Sensitivity Tests Output Drawings

Title **Hydraulic Modelling Addendum**

Job Name Peartree Hill Solar Farm

Job number 20-206

Figure 3-1 Missing Structures

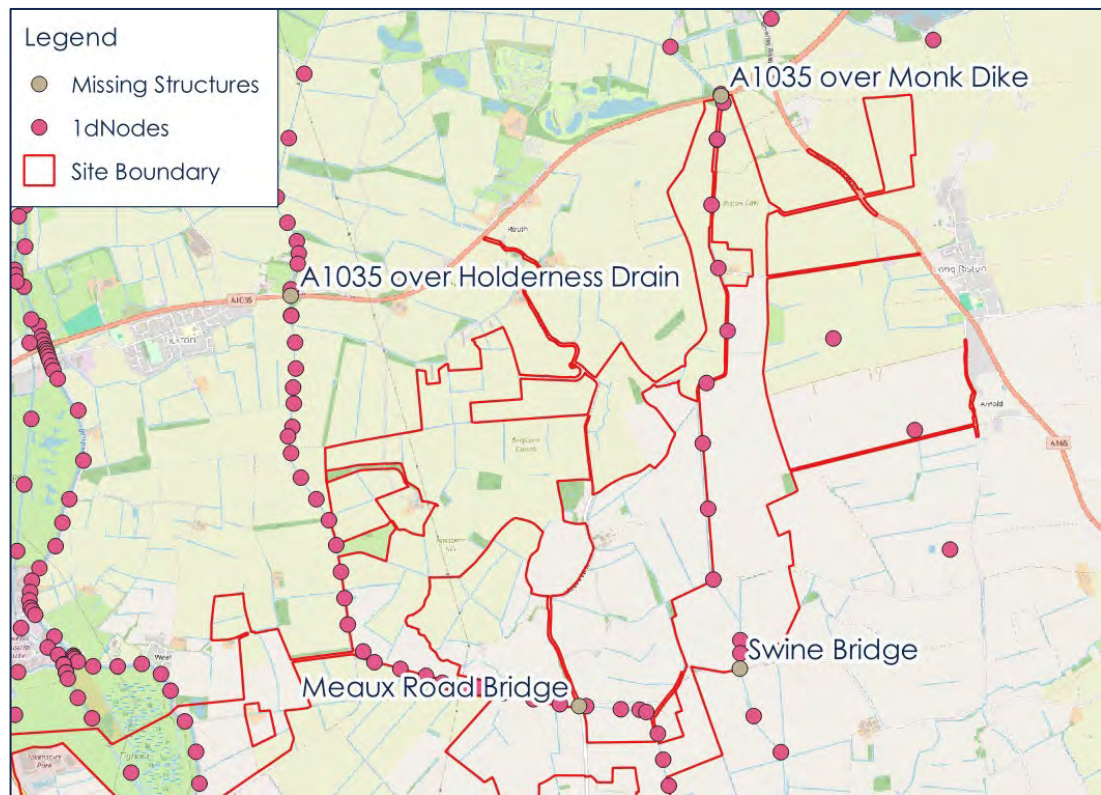
- 3.1.1 The EA model review notes a number of missing structure in vicinity of the site as listed below and shown in Figure 3-1:

- A1035 bridge over Monk Dike (FM cross section Cat00000)
- A1035 bridge over Holderness Drain (FM cross section HN43),
- Swine Road Bridge over Monk Dike (closest FM cross section MK4055), and
-  Meaux Road Bridge over Holderness Drain (FM cross section HN21).

- 3.1.2 Three of these structures have been added to the model using available data and where information was sparse a conservative approach to the structure definition was taken. The structure at HN21 as it appears to be a clear span structure with the deck approximately 3m above the maximum water level. Structure details definitions are appended to this document.

3.1.3 The model was reran with the design event flood. The maximum flood level was compared with the existing baseline design event outputs and the results are shown in Drawing 20-206-60-255-00 & 20-206-60-256-00.

3.1.4 Flood levels are generally within +/-20mm within the site boundary, the exception being a small part of parcel B1 where levels are reduced by 60mm and land west of parcel F12 where levels are reduced by 180mm. The only significant increase within the site are the parcels to the east of the Monk Dike (B2-4, B8 & C1-C3) where levels increase by 20mm. The change in outline is insignificant.

3.1.5 Given the very minor changes experienced in flood levels across the site it is concluded that the definition of these structures has no material impact on the flood levels, the mitigation (a freeboard of 300mm has been applied), or the layout.

1 A1035 BRIDGE OVER MONK DIKE

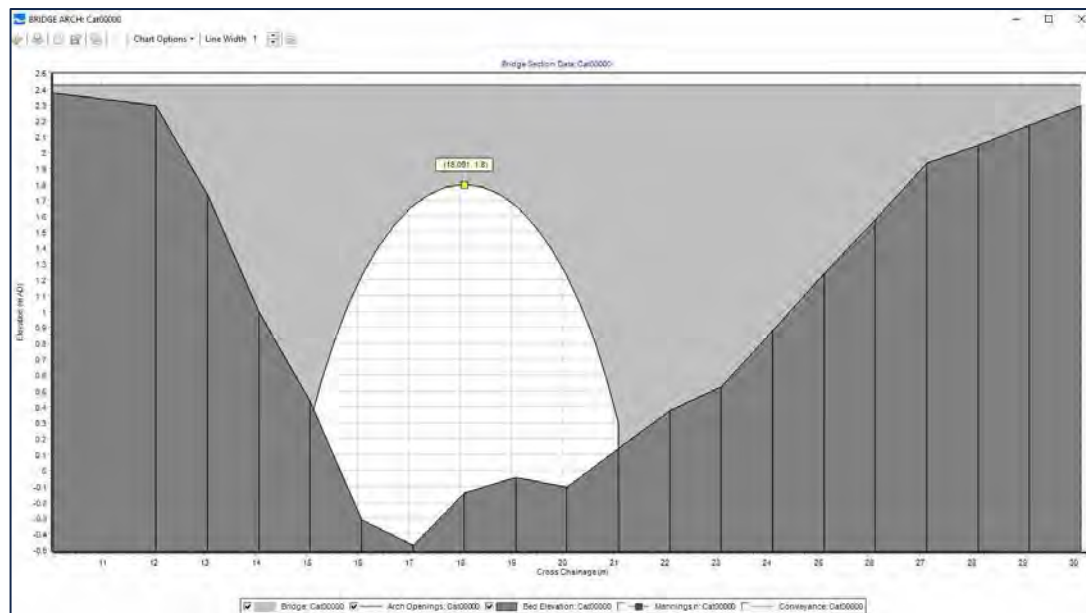
1.1.1 The arch bridge where the A1035 crosses the Monk Dike is located between node Cat00000 and Mk8550. The deck level is approximately 3.1mAOD.

1.1.2 The bridge dimensions were estimated with reference to the photos above and assumed brick dimensions of 225mm long, 113mm wide and 75mm high with and additional 10mm allowance for mortar. The parapet capping beam was assumed to be 225mm.

- The parapet was calculated to be 4.2mAOD. 1.1m high – ten course of bricks and capping beam $(85 \times 10 + 225) / 1000$
- The crown was calculated to be 1.8mAOD. 2.35m below parapet – two bricks lengthwise, one width wide, 18 courses and a capping beam $(2 \times (225 + 10) + 113 + 18 \times (75 + 10) + 225) / 1000$
- Springing height was calculated to be 0.3mAOD. 1.5m below crown 18 courses plus mortar $18 \times 85 / 1000$.
- The width of the bridge was estimated to be 6.1m, 26 lengths plus mortar $(225 + 10) \times 26 / 1000$.

1.1.4 The change to the model results in a reduction in peak flood level in the Monk Dike of 8mm. There is a minor reduction in flooding to the west of Monk Dike and minor increase in flood levels to east of Monk Dike (refer to Drawing 20-206-60-255).

2 SWINE ROAD BRIDGE OVER MONK DIKE

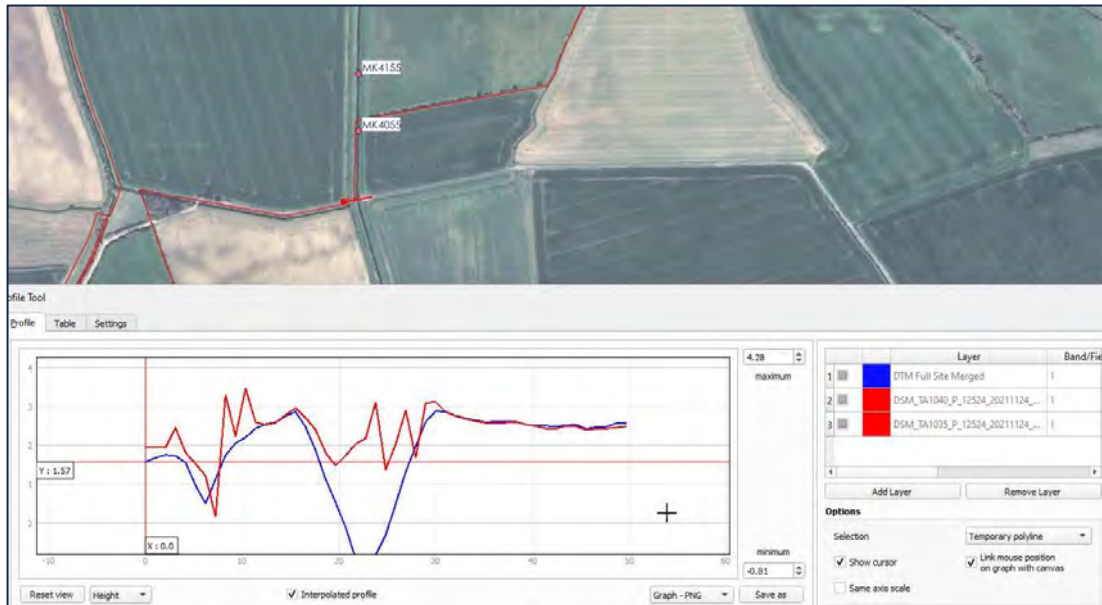
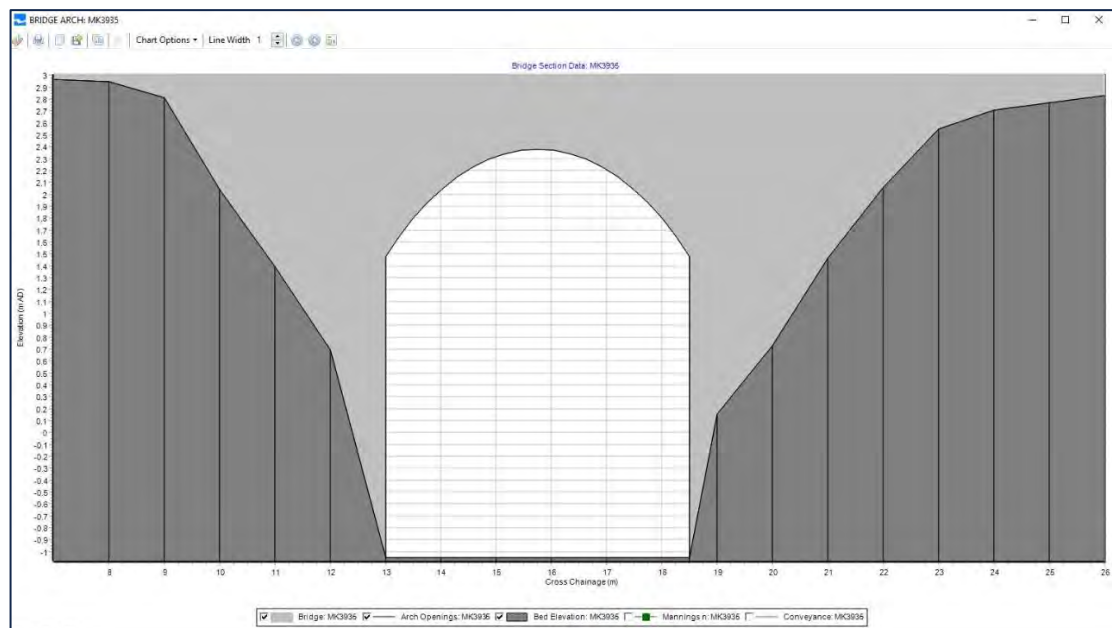
2.1.1 Swine Bridge is located between model nodes MK4055 and MK4355 just beyond the southern edge of parcel C7. The deck level is recorded by LiDAR as being approximately 3mAOD as shown below.

2.1.3 The bridge dimensions were estimated with reference to the photos above and assumed brick dimensions of 225mm long, 113mm wide and 75mm high with and additional 10mm allowance for mortar. The parapet capping beam was assumed to be 225mm.

- The parapet was calculated to be 4.1mAOD. 1.1m high – ten course of bricks and capping beam (85*10+225/1000)

- The crown was calculated to be 2.4mAOD. 1.7m below parapet – two bricks lengthwise, one width wide, 10 courses and a capping beam $(2*(225+10)+113+18*(75+10)+225)/1000$
- Springing height was calculated to be 1.5mAOD. 0.9m below crown 11 courses plus mortar $(11*85/1000)$.
- The width of the bridge was estimated to be 5.6m, 24 lengths plus mortar $24*(225+10)/1000$.

The peak flood level upstream of the bridge is within 1mm of the baseline model and consequently the definition of this bridge is not considered to be significant.

3 A1035 TICKTON BRIDGE OVER HOLDERNESS DRAIN

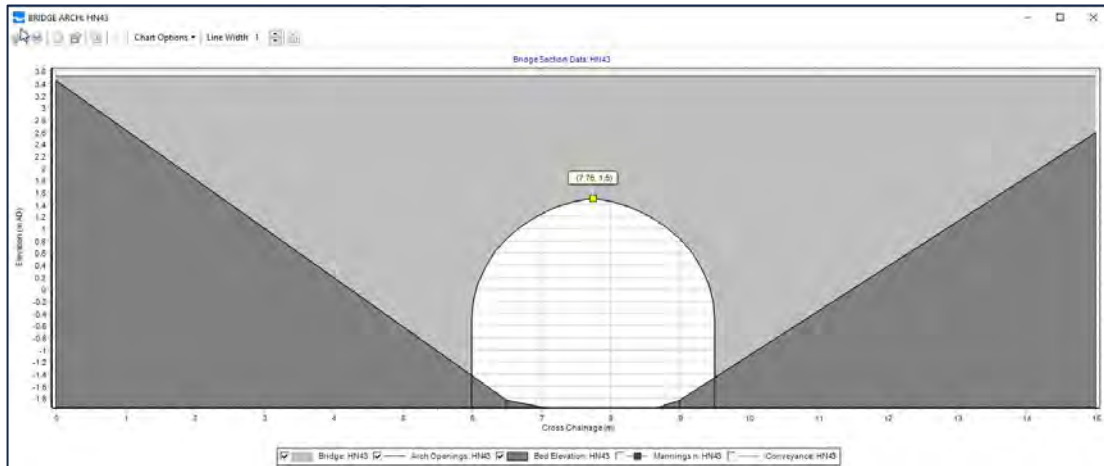
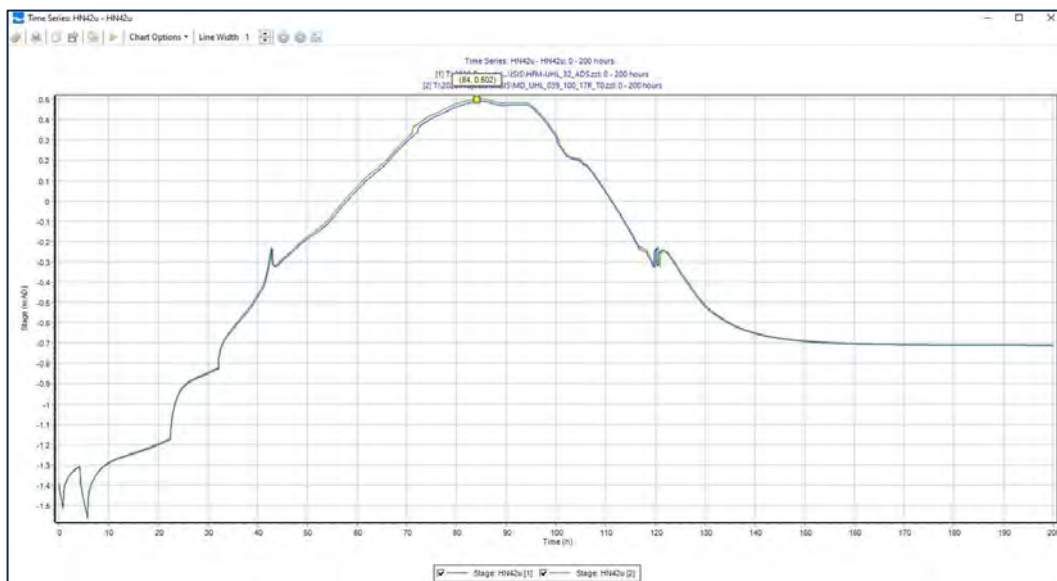
3.1.1 Tickton Bridge is located between model nodes HN43 and HN42. It is upstream of the application site. The deck level as recorded by LiDAR data is approximately 3.25m as shown below.

3.1.2 The only available information for the bridge is a photograph provided by the EA shown below.

3.1.3 It was estimated that the bridge opening is 3.5m wide with a 2m high arch and a total structure height of 3m as shown below.

- 3.1.4 The addition of the bridge results in an 11mm increase in water level just downstream of the structure as shown below and a negligible change in flood outline (refer to Drawing 20-206-60-255).

4 HN21

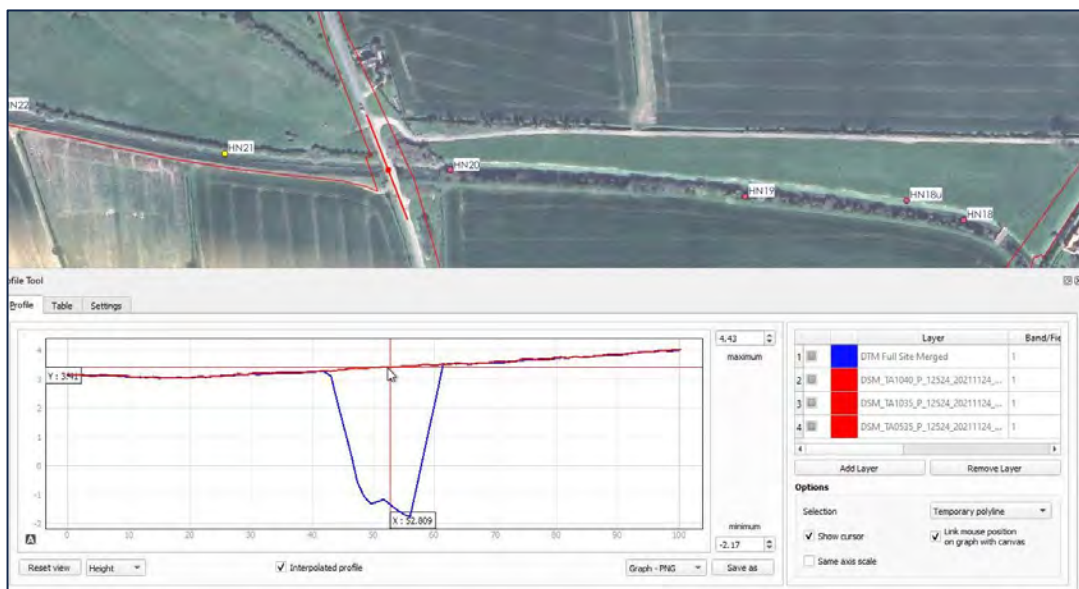
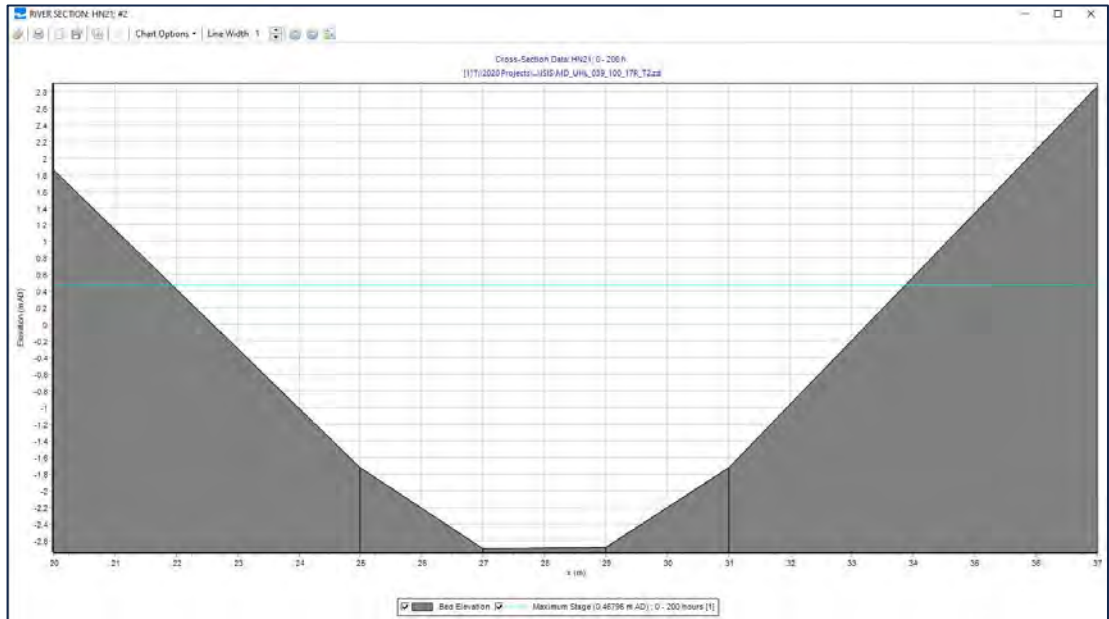
- 4.1.1 There is no bridge in the model between nodes HN21 and HN22 which is located adjacent to Parcel F6. The structure appears to be a flat deck, clear-span bridge as shown below

4.1.2 LiDAR data reports the bridge deck to be 3.25-3.5mAOD as shown below.

4.1.3 The maximum water level during the design event flood at node HN21 just upstream of the structure is 0.5mAOD as shown below. Consequently the soffit is likely to be much higher than the peak water level. The structure would therefore not impede flow and has not been added to the model.

Flow Sensitivity
Sheet 1 of 2

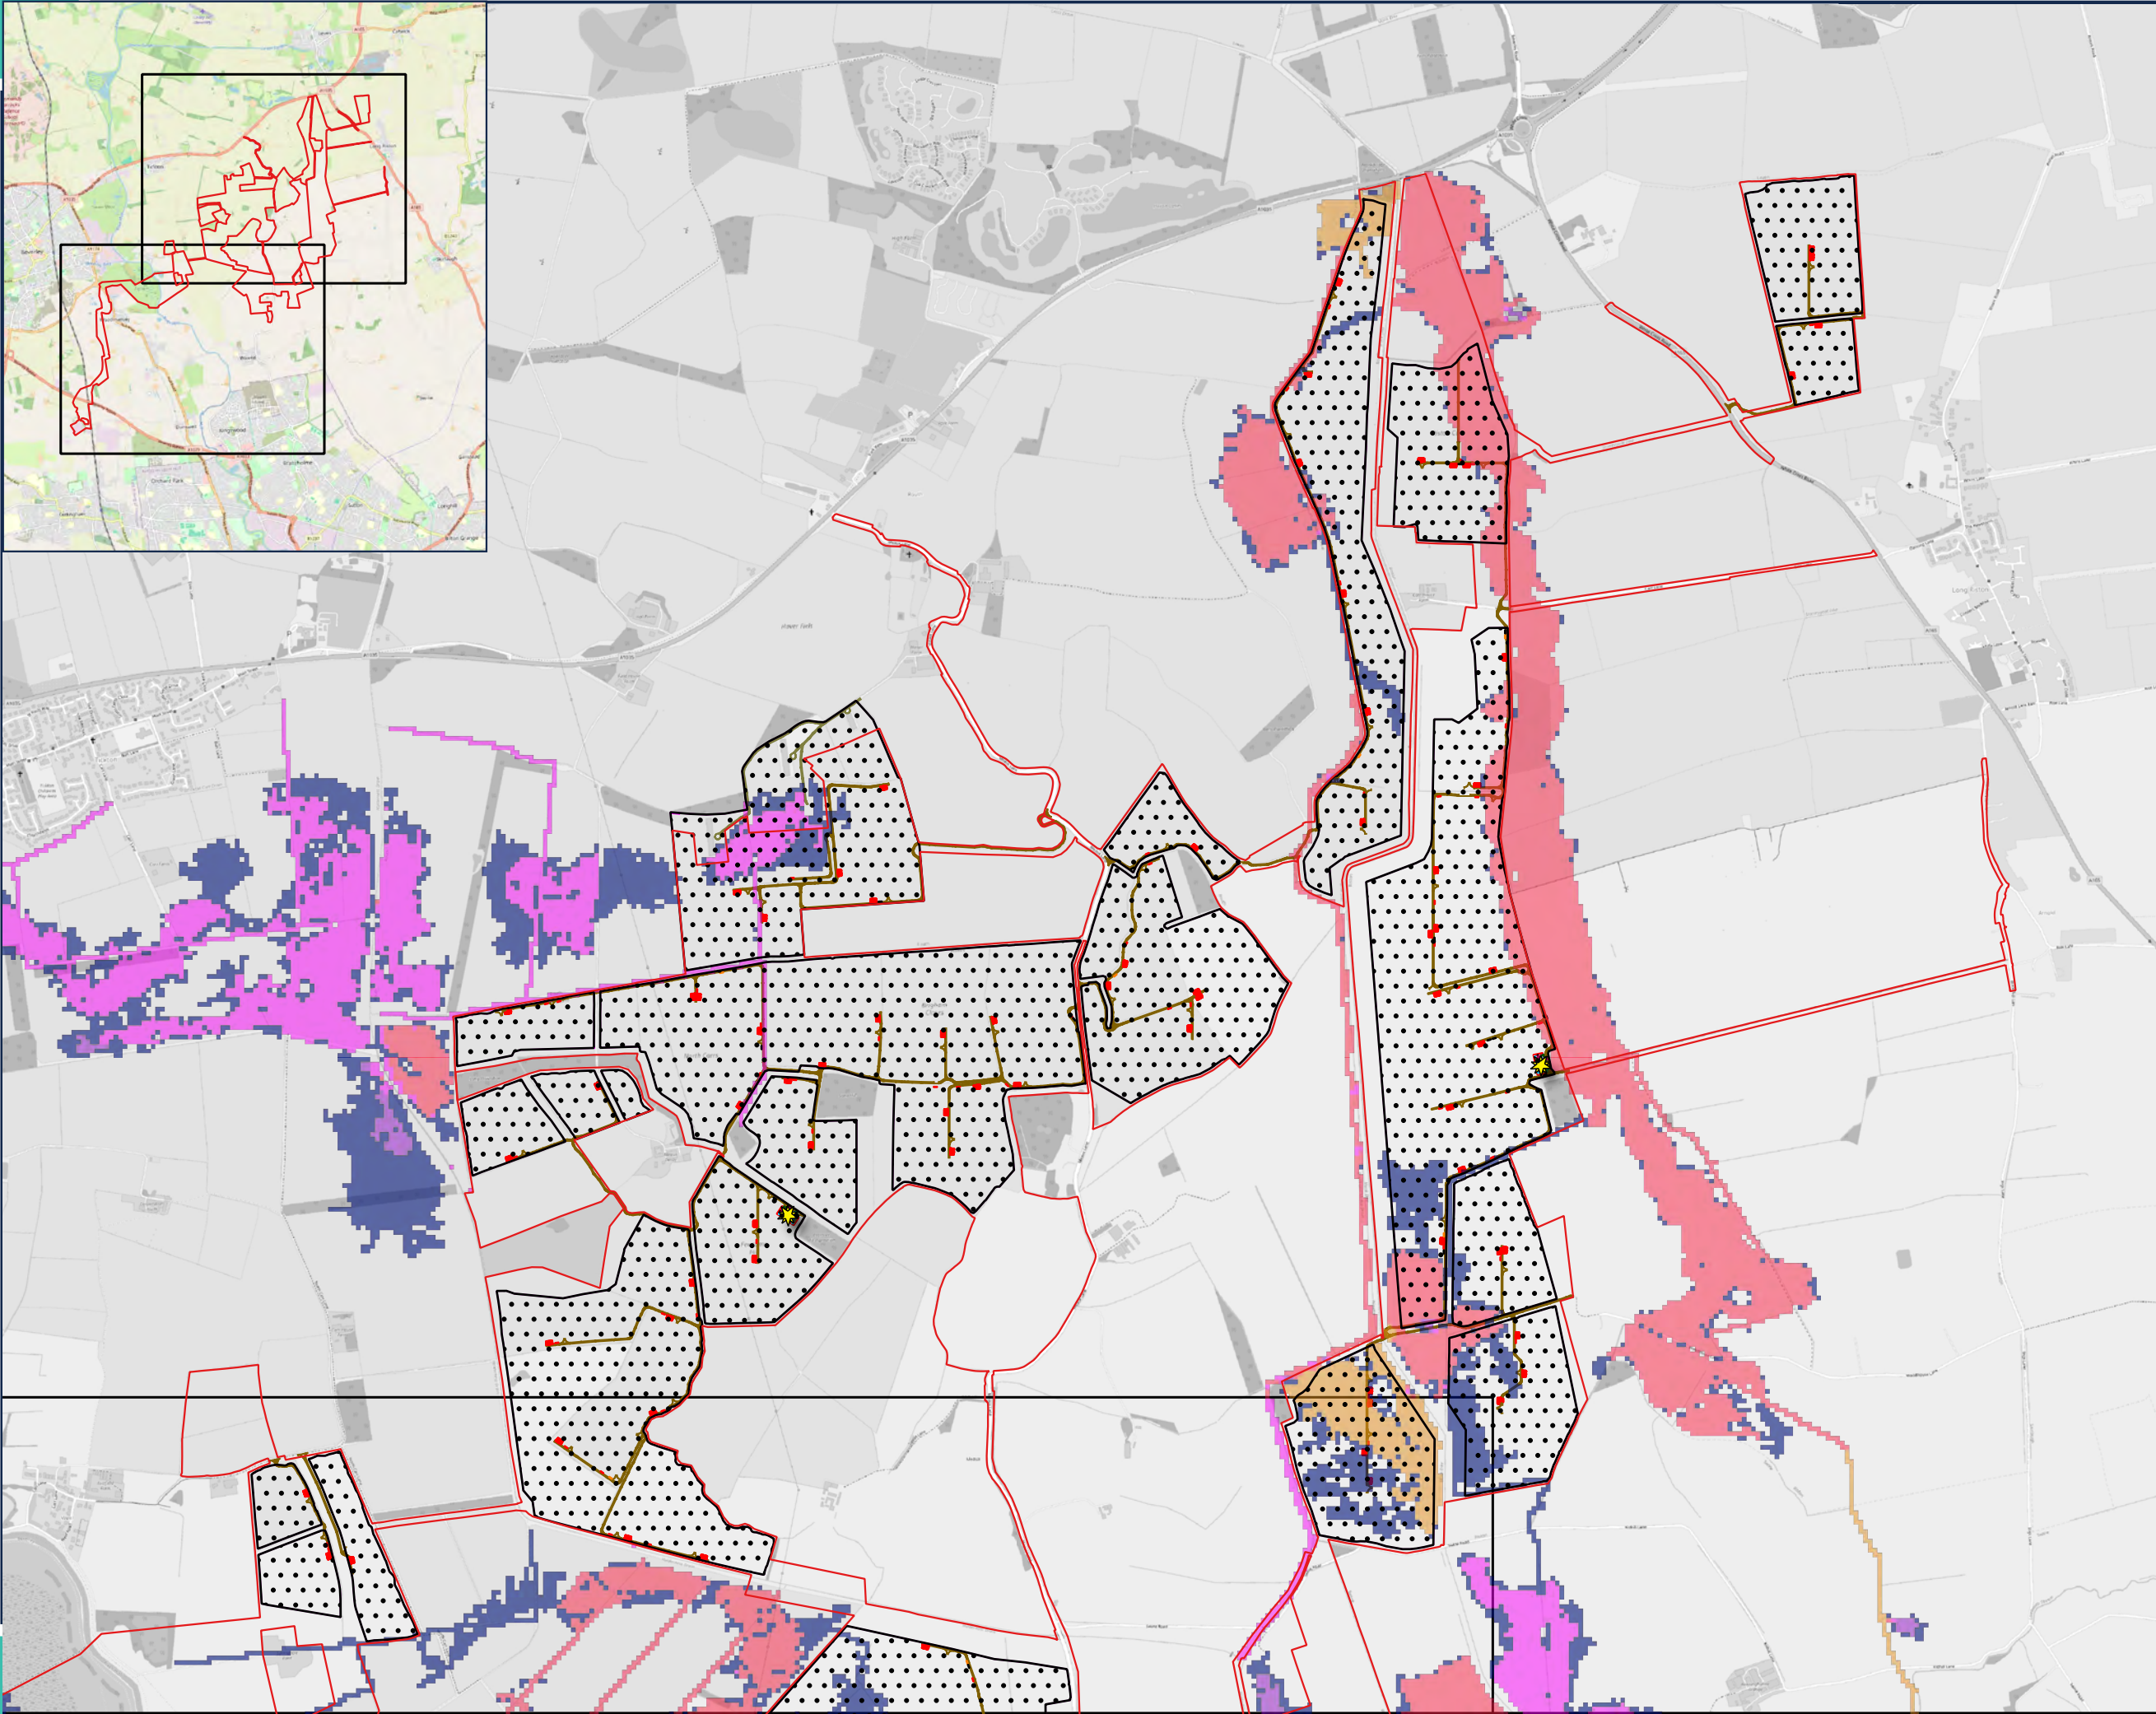
“There are some areas of additional flooding in the baseflow/SPR sensitivity test within the development area. Is sensitive infrastructure located outside of these areas?”

4.1.2 There is no sensitive infrastructure in these areas. Solar panels will be in these areas but will be raised significantly above the predicted flood levels. A revised version of the flow sensitivity drawings which includes containerised infrastructure and substation locations is appended to this note.

The containerised infrastructure appears as red blocks on this plan
